A G E N D A

Architectural Review Board

August 27, 2019

805 Felder Avenue

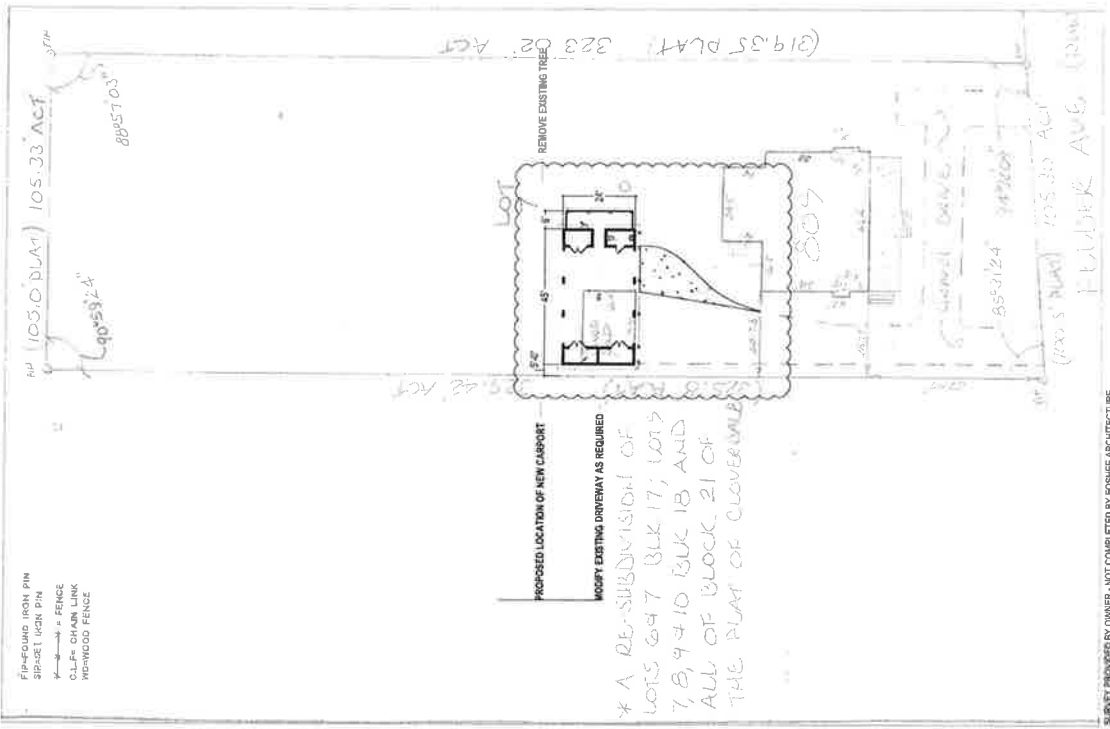
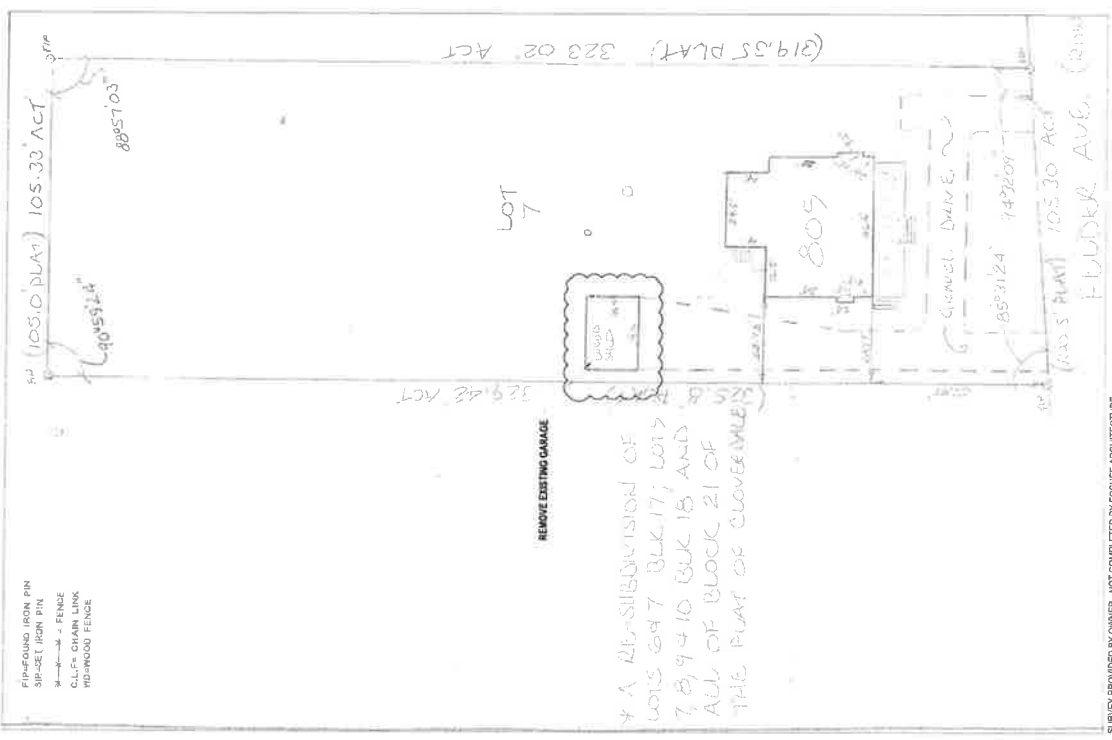
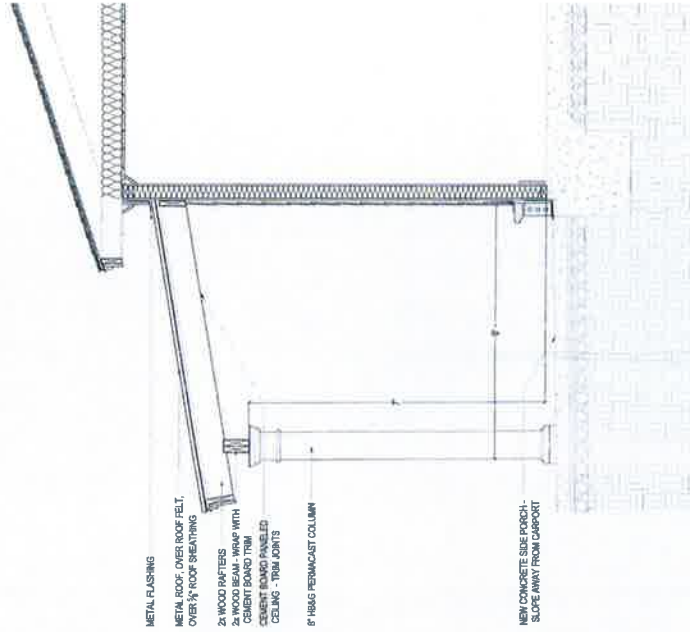
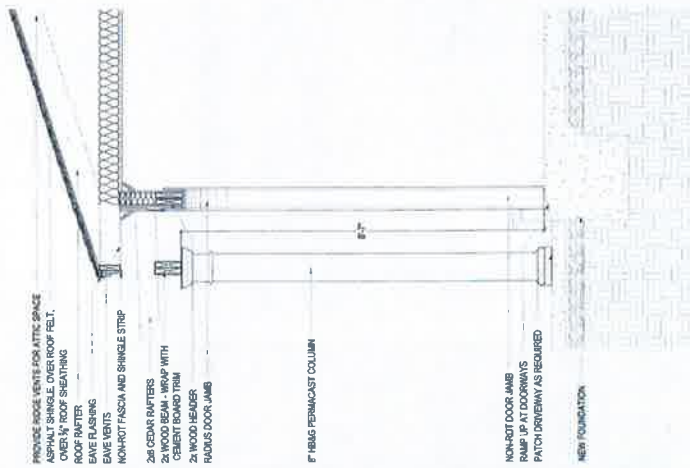
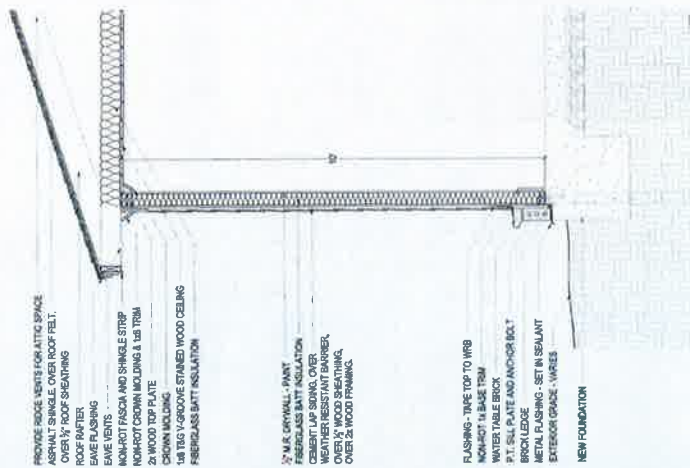
- No objection to the tree removal, it is in the footprint and there isn't much to it.
- The board has approved new outbuildings when they were compatible with the main dwelling and were scaled to be secondary to the main dwelling.
- The zoning allows 360 SF of lot coverage, a coverage variance from the Board of Adjustment will be required.

2040 South Hull Street

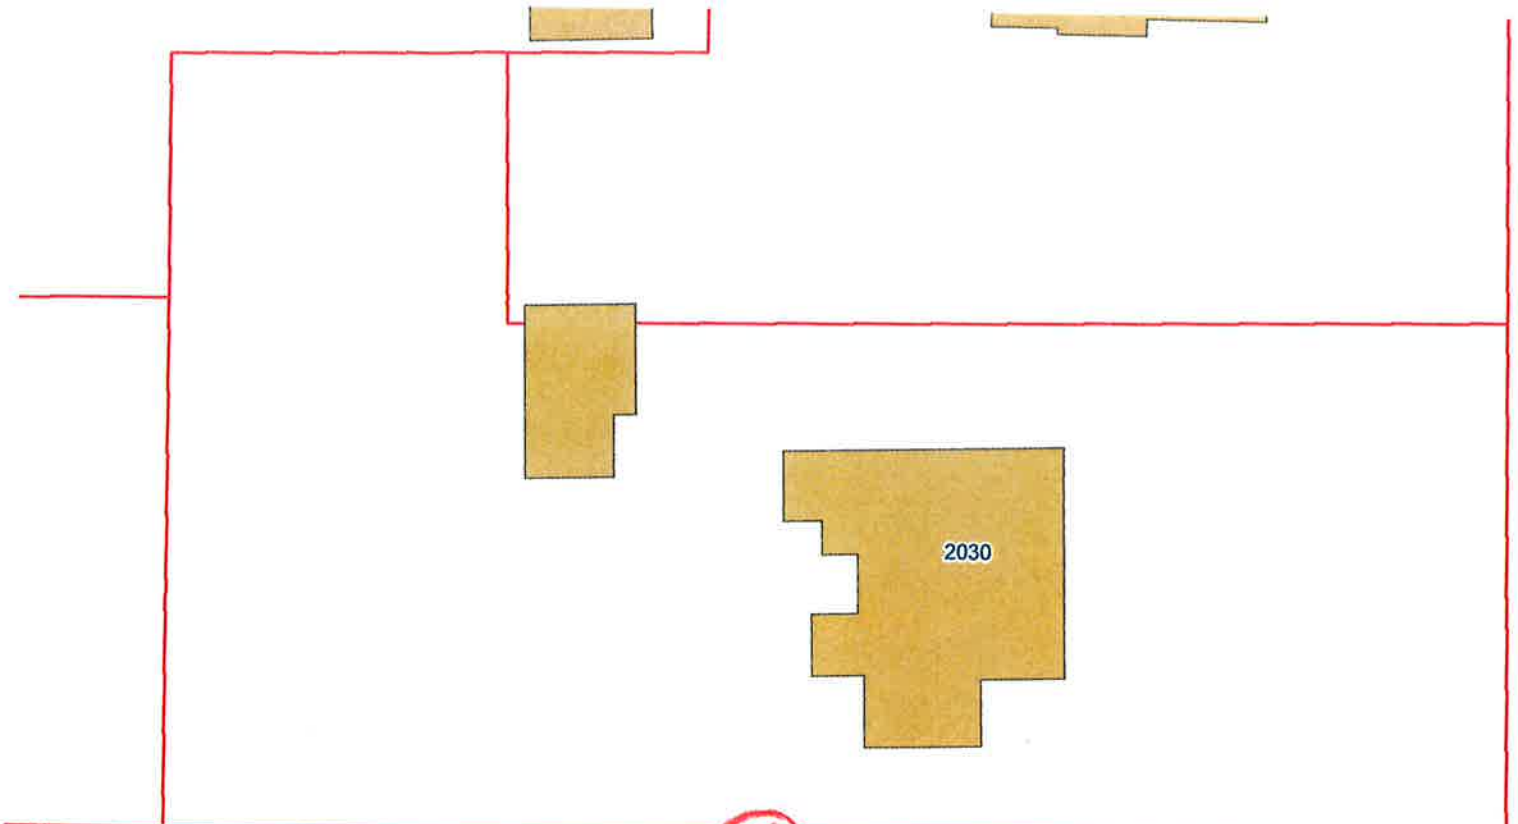
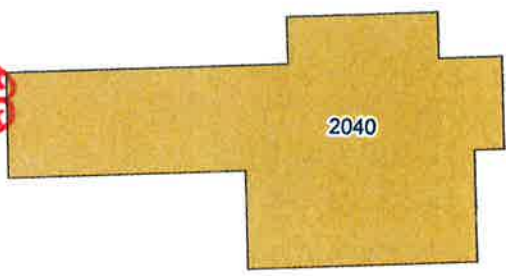
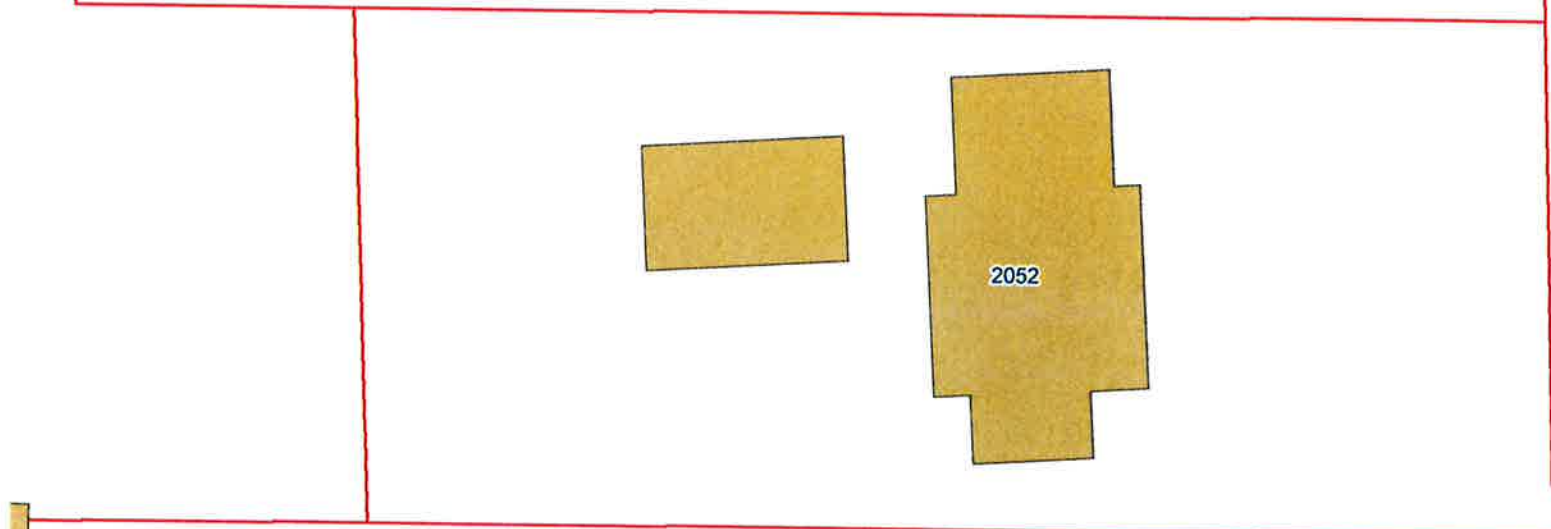
- The board has routinely approved the removal of Chinese tallow trees (invasive) and pecan trees when a suitable replacement has been proposed.

52 Adams Avenue

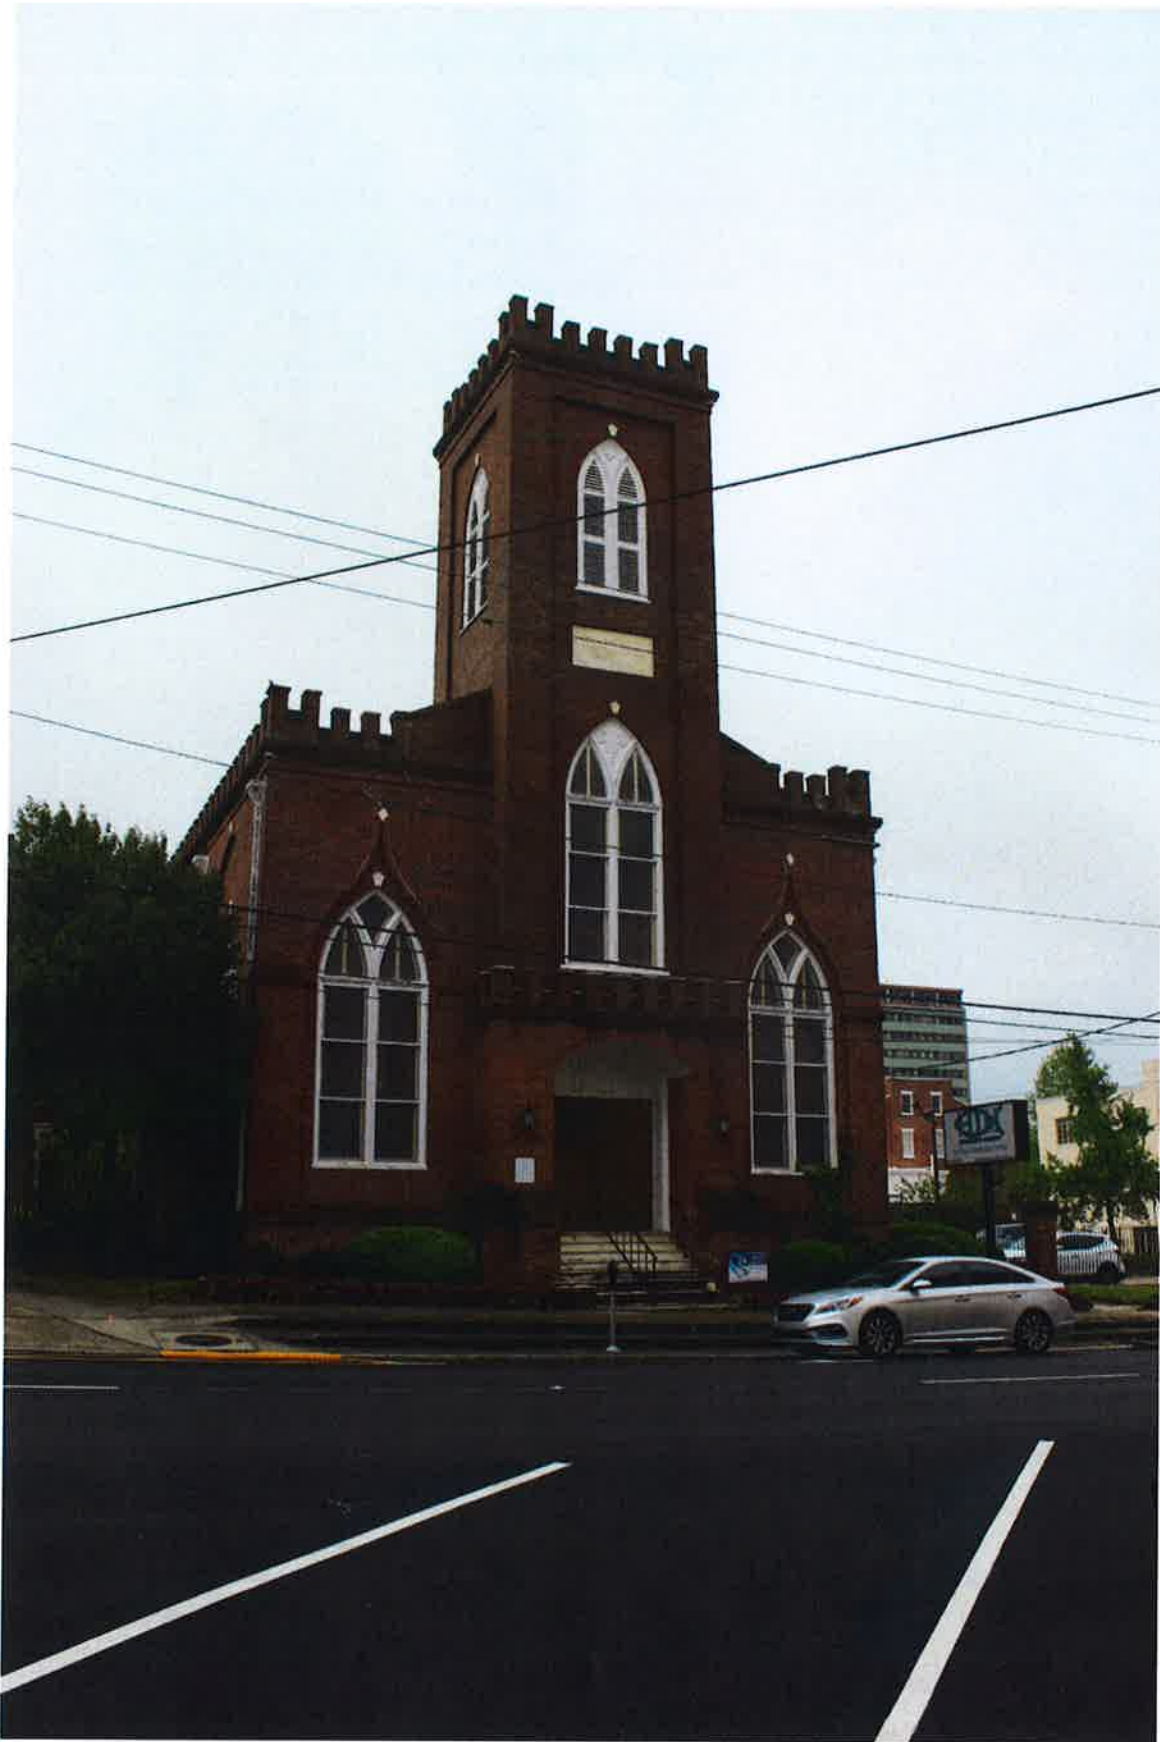
- This is a two part question, is the demolition warranted—either by condition or use? And is the replacement building a good, suitable replacement for the building to be demolished?
- As an individual designation, demolition inherently is detrimental to the district because it is the sole structure within that district. The National Register of Historic Places 7 qualities of historic integrity includes setting, feeling, and association. While this is an individual

landmark under local designation, the urban context of the National Register district in which it resides has been seriously eroded. It is one of three structures that remain on this city block, the other two face Court Street—the circa 1940 Moore Building and the antebellum (circa 1848) Lomax House.

- The board may consider the interest and use by the owner in its evaluation of the plans.
- The board has, in instances where a demolition request involves an architecturally significant structure, required measured drawings and photographs documenting the structure to be kept on record with Montgomery County Historical Society and an archive (the last set of drawings provided by Trinity Presbyterian Church were provided to the Montgomery County Archives).

- The board has also approved demolitions contingent upon salvaging materials. This has NOT been a requirement to save everything nor a requirement to make it available to a non-profit versus a commercial salvage operation, but that the owner afford the opportunity to entities who do architectural salvage to determine what they deem worth saving based on its potential reuse/marketability.

- In addition to delaying a decision for up to 6 months to allow for the exploration of other opportunities/potential outcomes, the Board is within its right to delay a decision if it is determined more work needs to be done on the replacement plan.
